DEVELOPMENT APPLICATION ASSESSMENT REPORT

Application Number:	DA2025/0572
----------------------------	-------------

Responsible Officer:	Lachlan Rose
Land to be developed (Address):	Lot 2 DP 210657, 24 Ogilvy Road CLONTARF NSW 2093
Proposed Development:	Demolition works and construction of a dwelling house including a swimming pool
Zoning:	Manly LEP2013 - Land zoned R2 Low Density Residential
Development Permissible:	Yes
Existing Use Rights:	No
Consent Authority:	Northern Beaches Council
Delegation Level:	DDP
Land and Environment Court Action:	No
Applicant:	David Edward La Rose

Clause 4.3 Height of Buildings

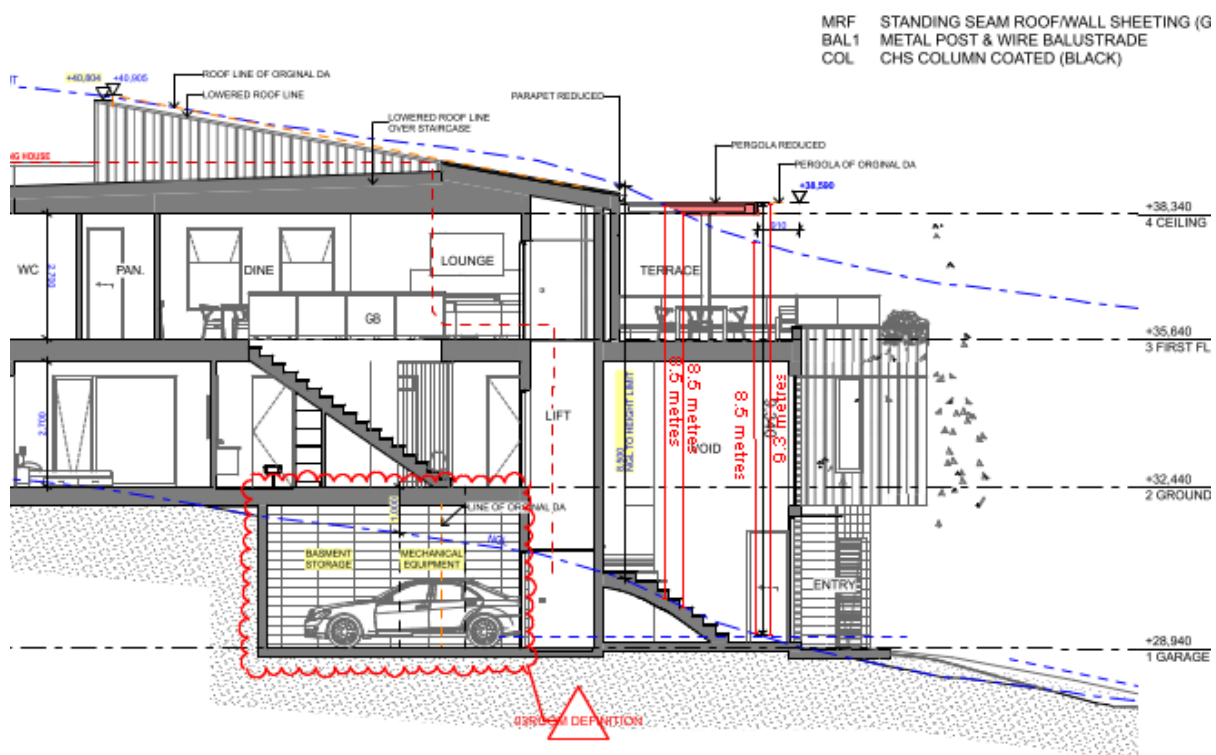
The application seeks consent to vary a development standard as follows:

Development standard: Clause 4.3 Height of Buildings

Council is satisfied that the Applicant has demonstrated that there are sufficient environmental planning grounds to justify the contravention of Clause 4.3 for the following reasons:

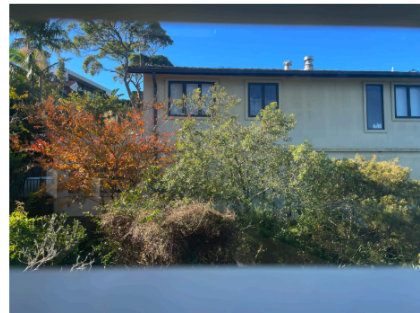
The development is amended to result in a greater rear setback to the first floor balcony with a reduced balcony area. Due to the balcony being low in nature, of a minimal area and to a master bedroom, it is not considered to result in unreasonable privacy loss to the rear properties.

The western side elevation reflects minimal window designs that will allow for light penetration for the occupants and privacy for the adjoining neighbour. The adjoining property to the west is located at an estimated 4.3m from the subject property and includes the use of narrow windows to limit a loss of privacy.

4.1.1.1 Residential Density and Dwelling Size

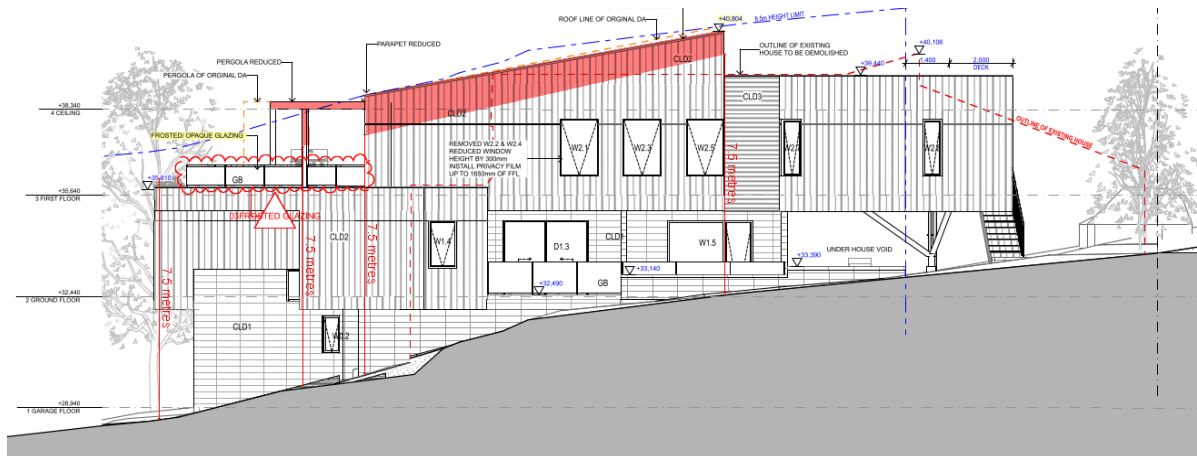
The development is located within the residential density area D7 which requires 750sqm of site area per dwelling. The existing site includes a dwelling house, where the proposed development will demolish the existing dwelling and provide a new single dwelling.

The site area is surveyed at 470.1sqm and therefore, the site results in a non-compliance of 59% (279.9sqm). It should be noted that there are no proposed changes to the residential density of the site under this application and thus, Clause 4.1.1.1 Residential Density and Dwelling Size is not applicable in this instance.
